ARCHITECTURAL REVIEW

AR-17-0007

**** APPROVAL WITH CONDITIONS ****

Project: Rivercrest Meadows Apartments – Clubhouse Conversions

A1.00
SITE PLAN

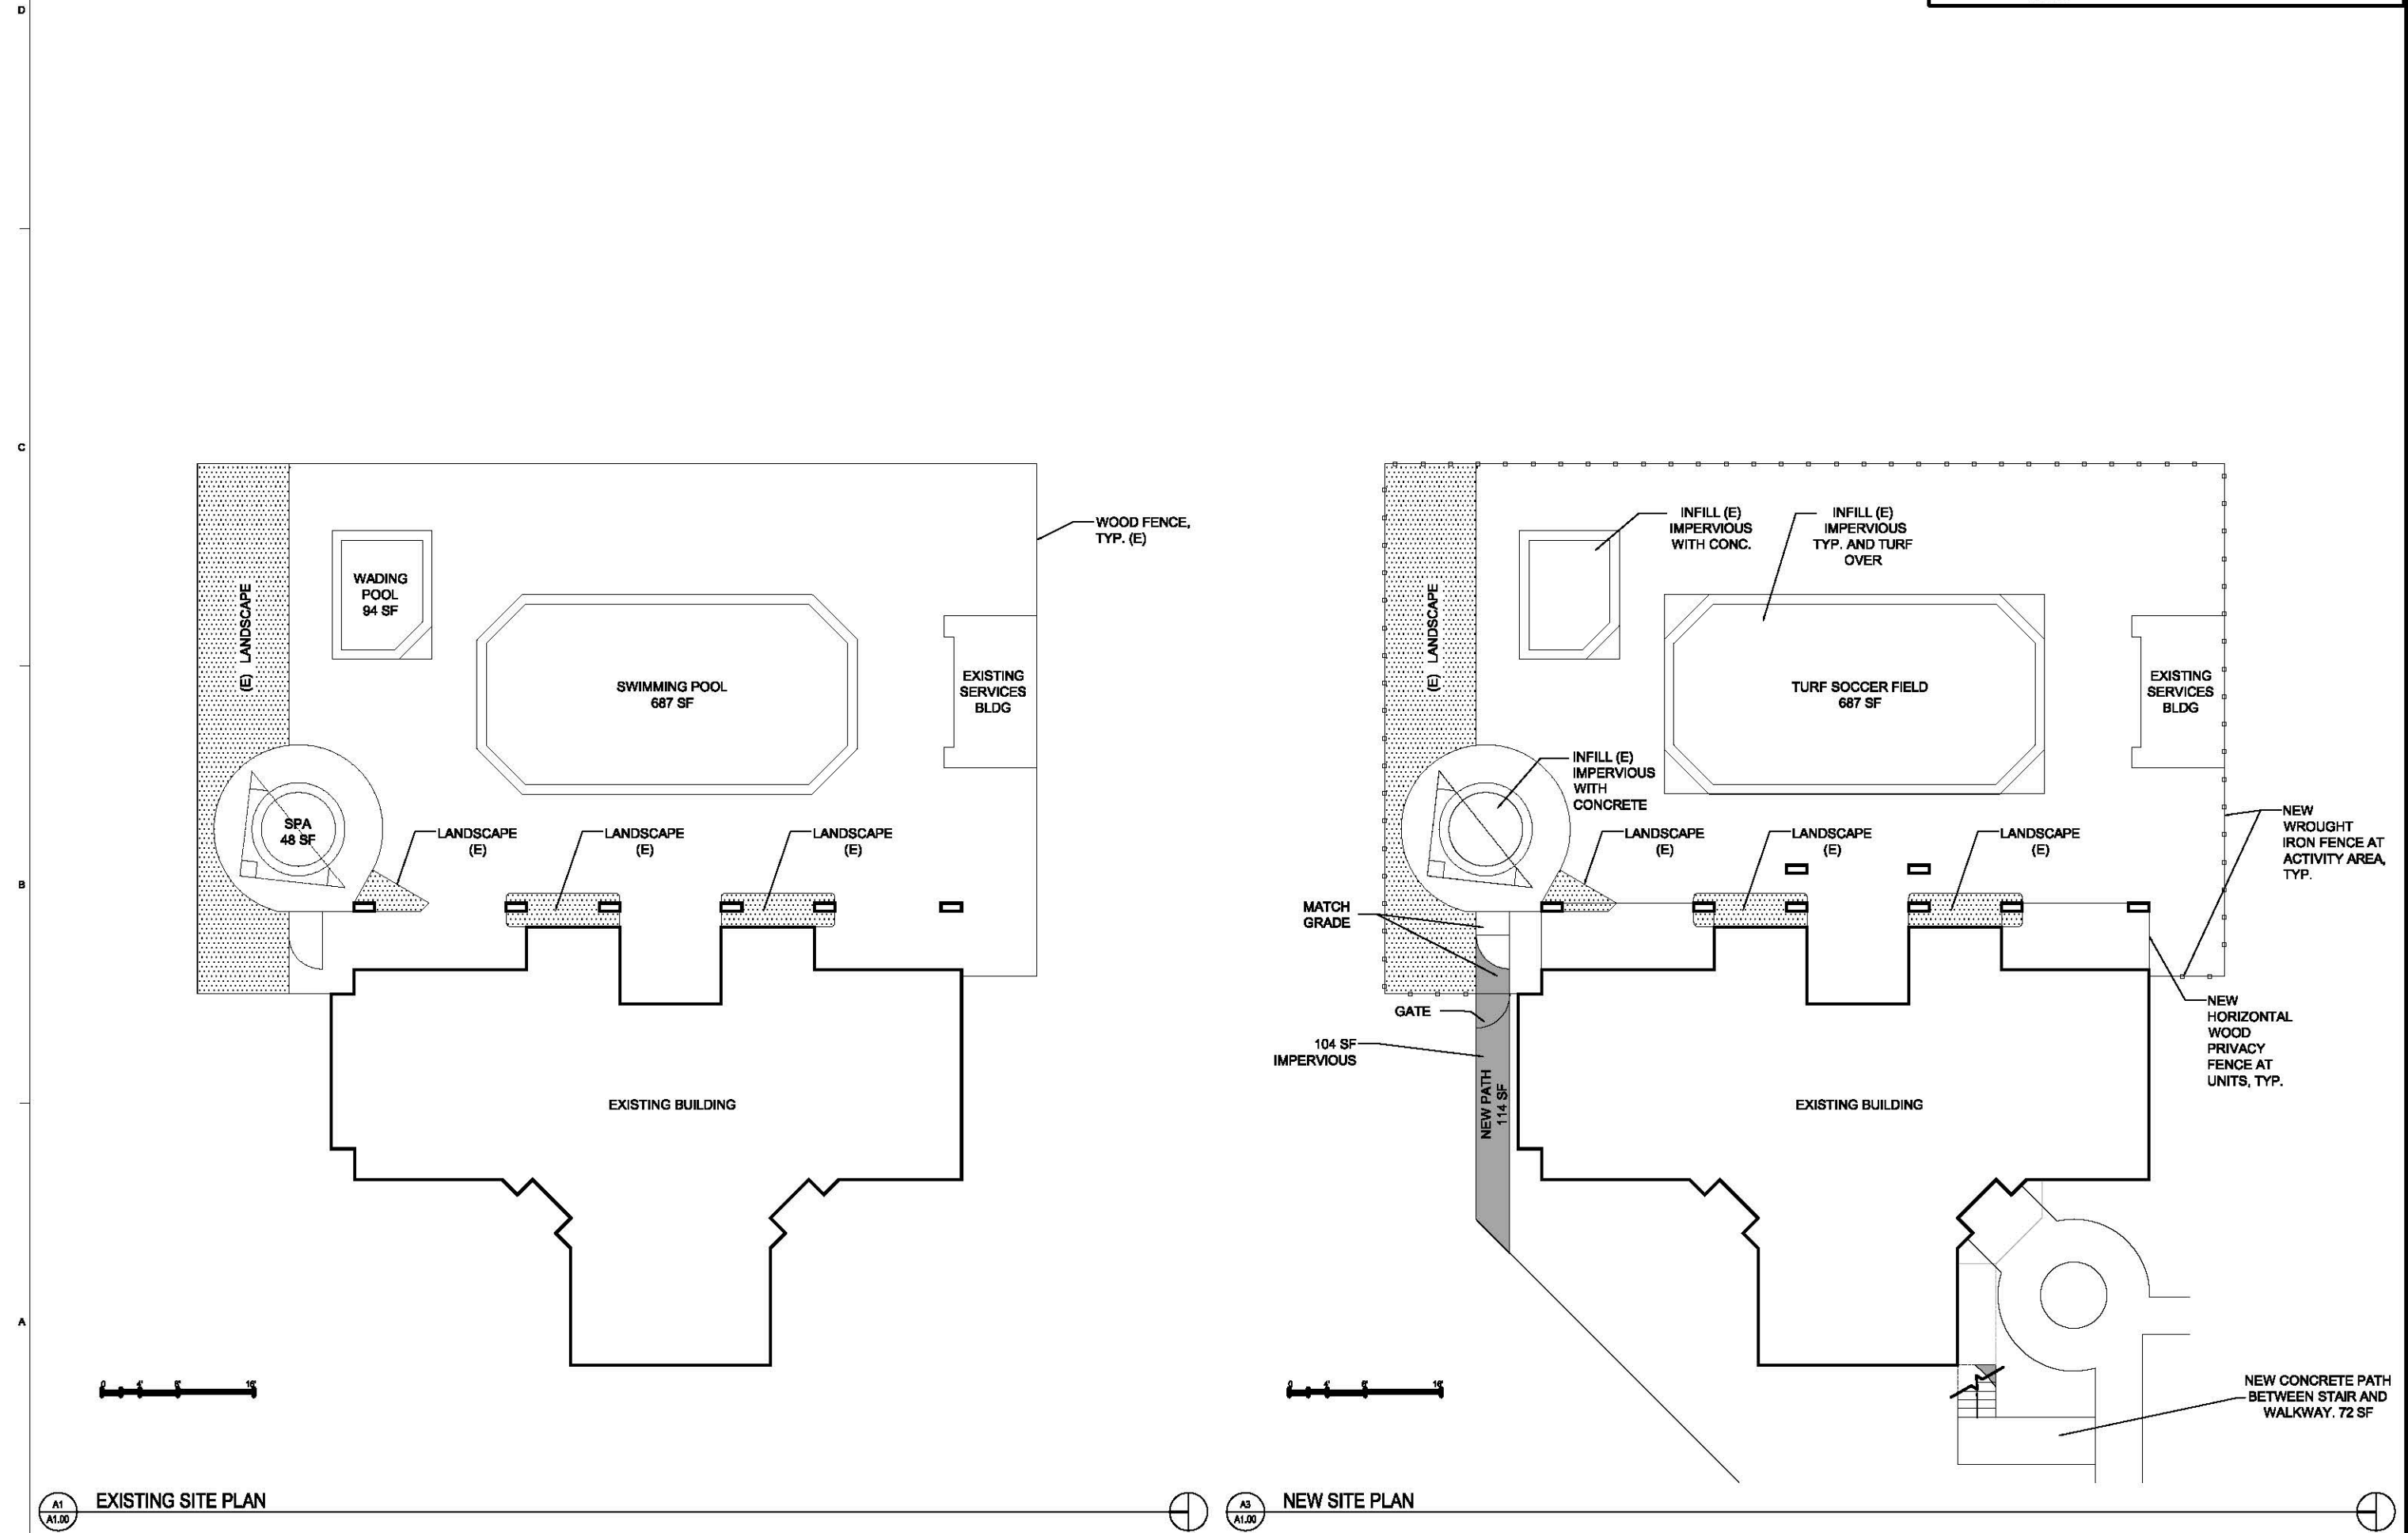
The applicant is proposing four additional parking stalls as shown on Site Plan Sheet A1.01, dated 12.14.17 and as described in TDC 73.370. These stalls are located near the existing building and approximately 130 feet away from SW Tualatin Road and approximately 48 feet from a property line. This standard is met.

This proposal also includes infill of an existing wading pool, jacuzzi, and swimming pool. The swimming pool is to be converted into a 687 square foot turf "soccer field" as shown on Site Plan Sheet A1.01, dated 12.14.17. No details are provided for the finished treatment of the wading pool and jacuzzi. It is unclear to staff what sort of amenity the filled wading pool or jacuzzi will serve.

The applicant has not addressed this standard in their application. An existing mail facility is located adjacent to the proposal, as noted on Site Plan Sheet A1.01, dated 12.14.17. A condition has been added to ensure the standard is met.

The applicant has not addressed this standard, nor has a Landscaping Plan been included in their application. On and above-grade electrical and mechanical equipment is located near the proposal as shown on Site Plan Sheet A1.01, dated 12.14.17. Staff also observed additional equipment on the north

Walkways are proposed to the staircase leading to the upper unit, along a new parking stall, and to an entrance of the fenced yard of the subject building as shown on Site Plan Sheet A1.01, dated 12.14.17. The walkways are proposed to be concrete and four feet in width. No ramp details are provided where the new walkways connect to the parking areas. It additionally appears that a walkway is proposed over existing utility equipment and tree. Conditions have been added to ensure these standards are met.

The applicant has not provided a landscape plan. Landscape areas will be disturbed by proposed walkway and parking improvements, as shown on Site Plan Sheet A1.01 (dated 12.14.17). A condition will ensure this standard is met.

Condition of Approval: The applicant must revise the appropriate sheets to note the location of postal delivery areas for the proposed three units pursuant to TDC 73.130(5)(a)and(b). Postal delivery areas must be well lit and provide safe pedestrian access.

Condition of Approval: *The applicant must provide a landscaping plan that illustrates on and above-grade electrical and mechanical equipment is screened with sight obscuring fences, walls, or landscaping pursuant to TDC 73.130(5)(c).*

Condition of Approval: The applicant must revise the appropriate sheets to increase the width of proposed walkways to six feet pursuant to TDC 73.130(7). Curb ramps must be provided wherever a walkway crosses a curb.

Condition of Approval: *The applicant must provide a landscape plan that illustrates all areas not occupied by buildings, parking spaces, drive aisles, and pedestrian areas are landscaped pursuant to TDC 73.300. Proposed landscaping must meet the tree and plant specification standards of TDC 73.260.*

**C1
A2.10** EXISTING FLOOR PLAN - FIRST FLOOR

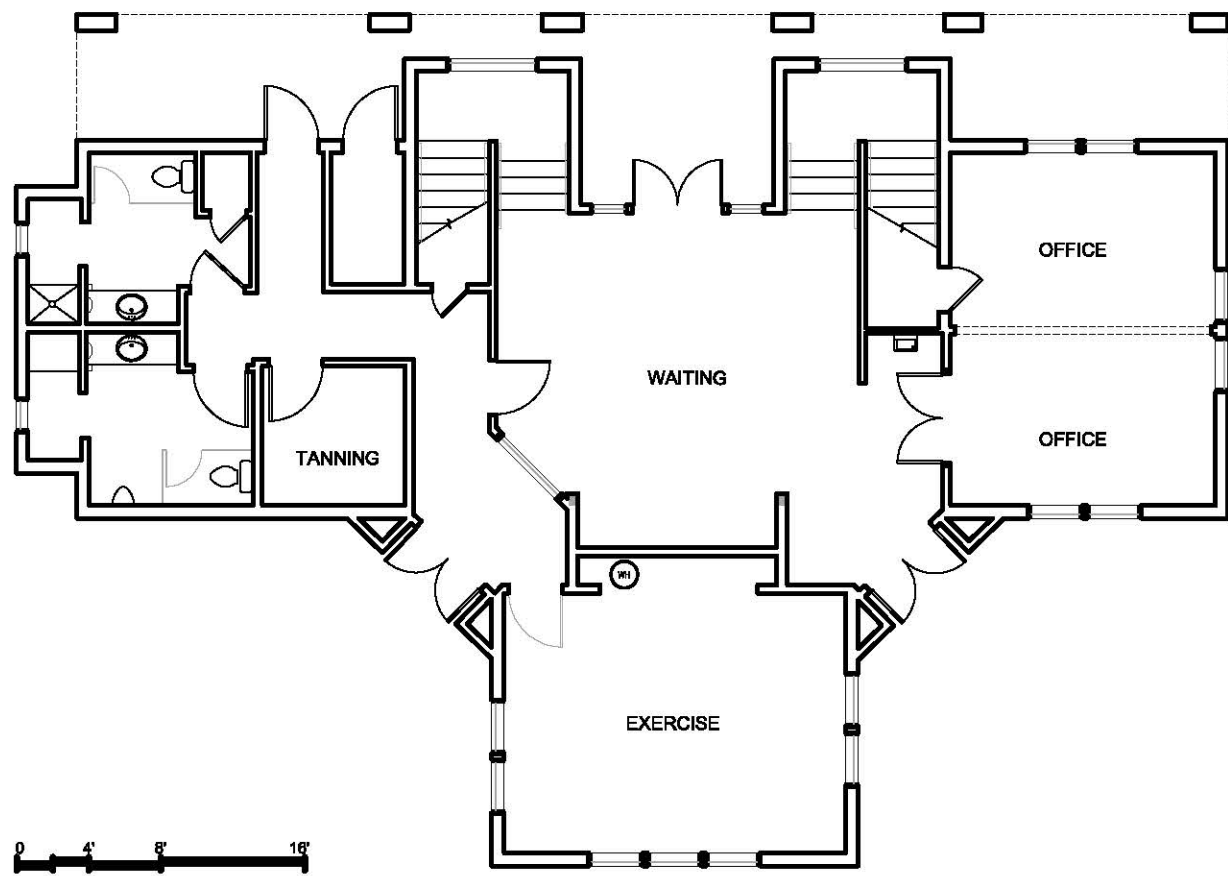
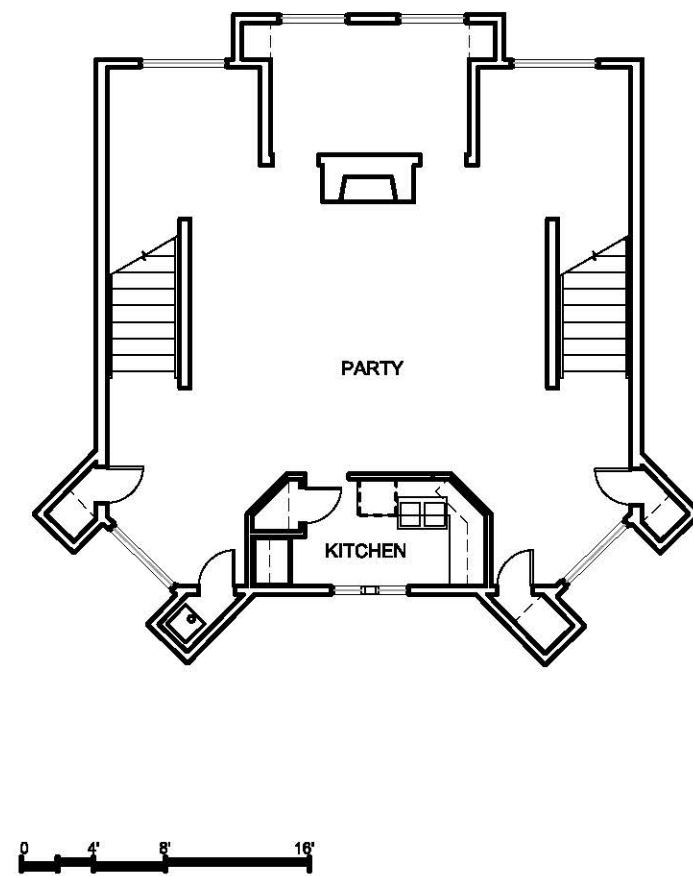
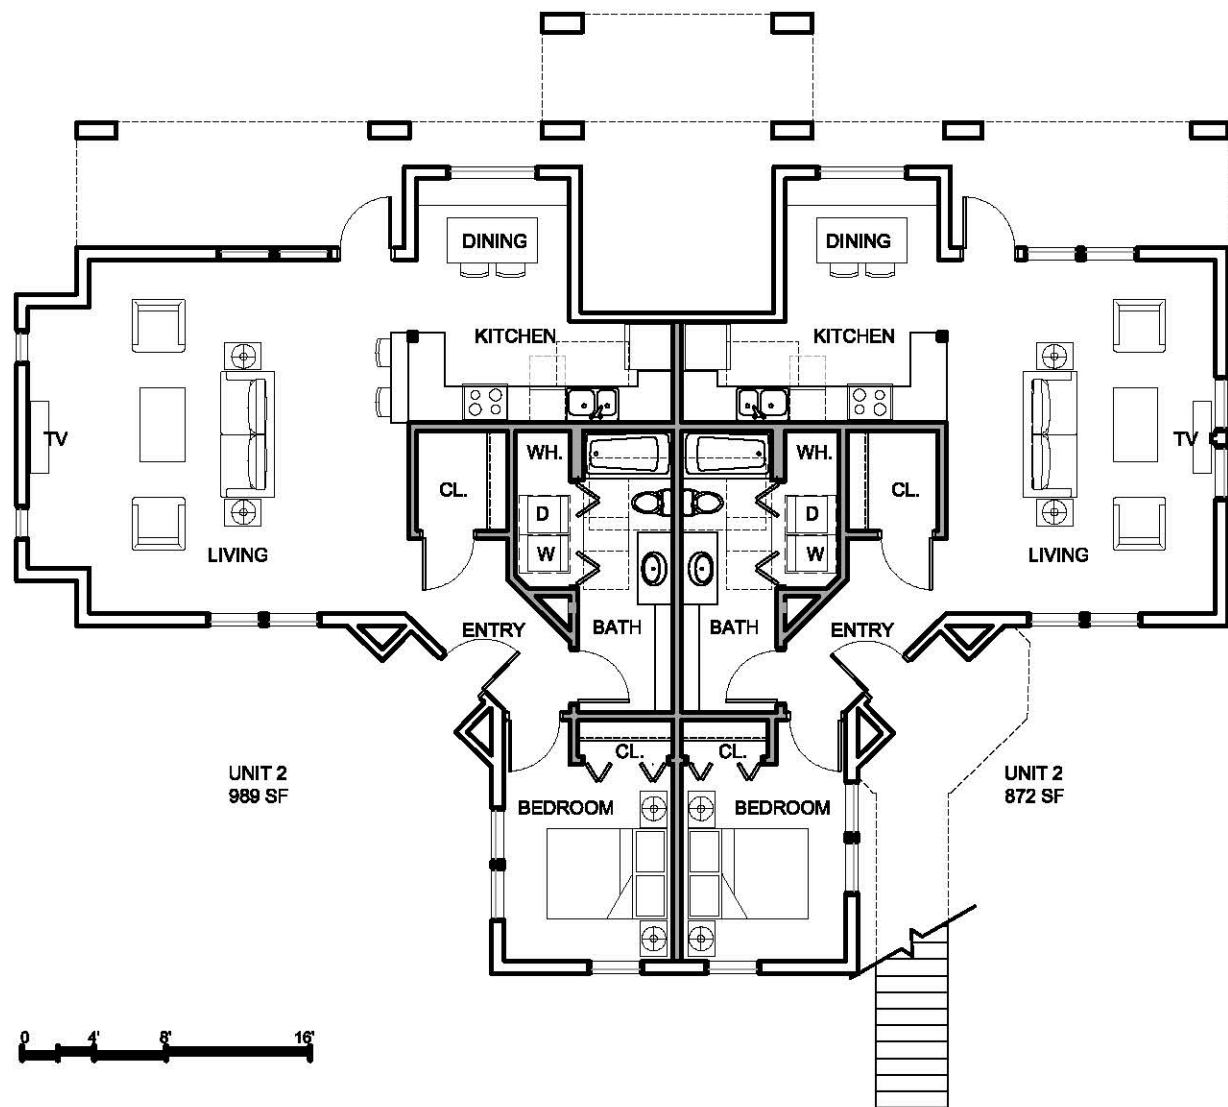
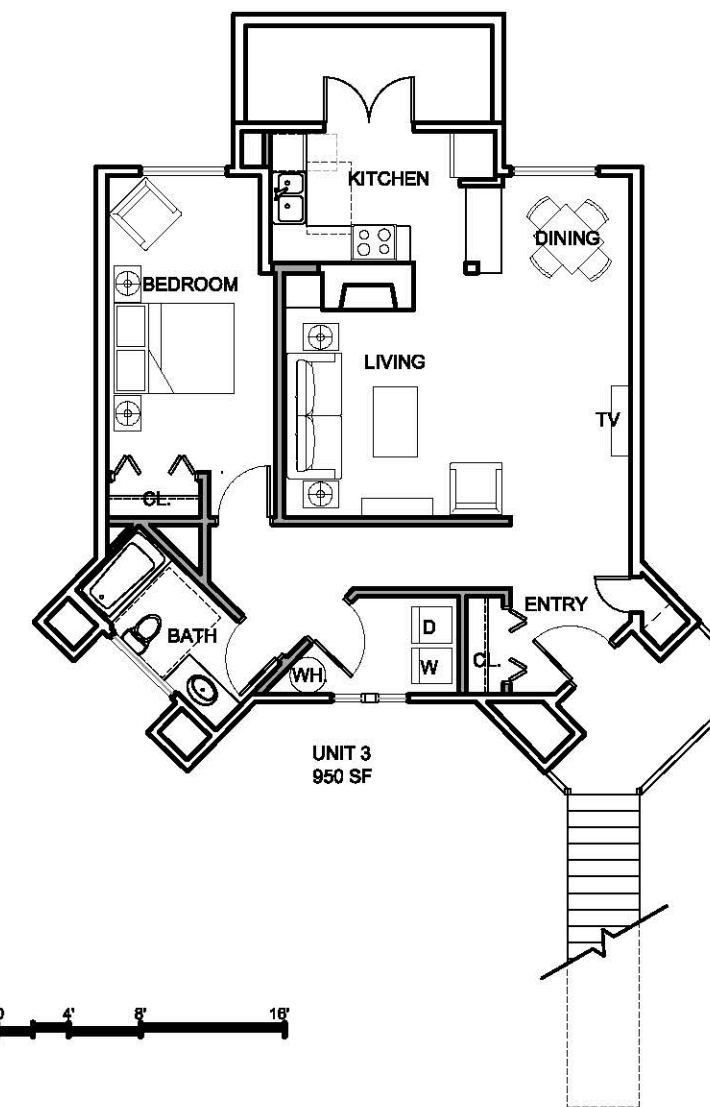
The proposal is not located in the Central Design District or within the Mixed Use Commercial Overlay District. Two units proposed on the lower floor each include approximately 84 square feet of fenced private outdoor area as shown on Floor Plans Sheet A2.10 dated 12.13.17. One unit is located above ground level. This unit includes a 48 square foot balcony as shown on Floor Plans Sheet A2.10 dated 12.13.17. These standards have been met.

One-bedroom units are proposed. This requirement is met on Floor Plans, Sheet A2.10 (dated 12.13.17).
